Minute No. 286
Report - Standing Policy Committee on Property and Development - March 4, 2003

Item No. 4 Proposed Amendment to Development Agreement - Canterbury Park, south of Kildare Avenue East and east of Ravenhurst Street
File DASZ 42/87

Re: Canterbury Park, south of Kildare Avenue and east of Ravenhurst Street – DASZ 42/87

MAP 2 to Report dated February 5, 2003 for AG 42/87

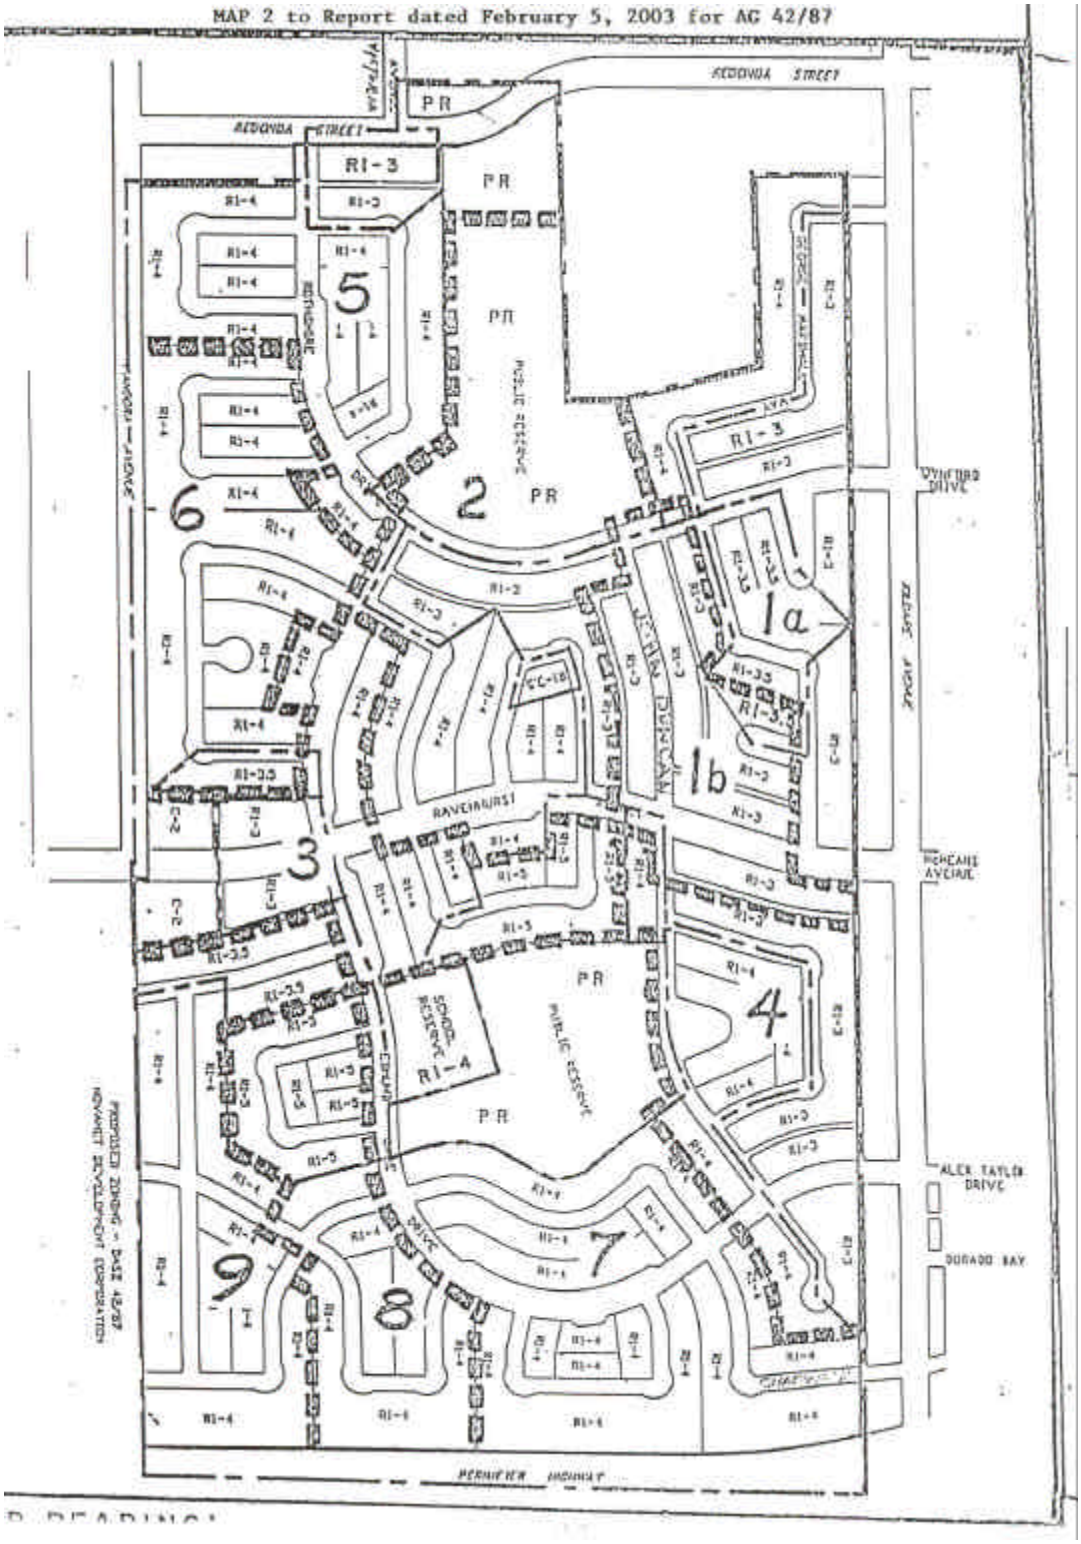
Council at its meeting held on May 31, 1989 approved DASZ 42/87 being an application by Novamet Development Corporation to subdivide and rezone approximately 240 acres of land located south of Kildare Avenue and east of Redonda Street. A copy of the approved plan is attached hereto and identified as Map 1. At the Developer's request, Council at its meeting held on August 2, 1989, approved the registration of the approved plan of subdivision in phases in accordance with the plan attached hereto and identified as Map 2. To date only the following portions of the approved plan of subdivision have been registered:
